**RE: Belle Fourche Pipeline Company
6-inch Skunk Hill-DPR Pipeline Conversion
Siting Application - Case No. PU-18-405
Our File No. 013084-000014**

47 PU-18-405 Filed 06/10/2019 Pages: 64
Exhibit 2 - Responses to PSC Staff Information Request of January 14, 2019
Belle Fourche Pipeline Company

North Dakota USFWS Wetland Management Districts

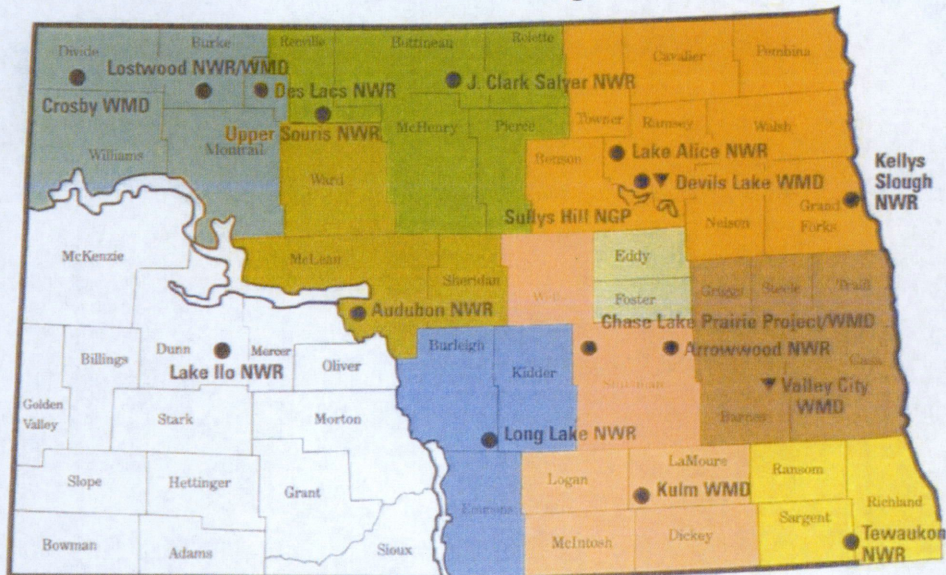
Request 5. Concerns or rationale that led you to send a letter to the Lake Ilo National Wildlife Refuge. Table 7 indicates a letter was sent on 06/22/2017. Does the Project corridor pass through this refuge?

Response. The Project corridor does not pass through the Lake Ilo National Wildlife Refuge ("NWR"). Belle Fourche submitted a letter for comment to the Lake Ilo NWR because this office manages the most up-to-date information for conservation easements for counties in southwestern North Dakota (see below). NWR's will sometimes provide information and comments related to PSC projects; however, to date, no formal response has been received from the Lake Ilo NWR.
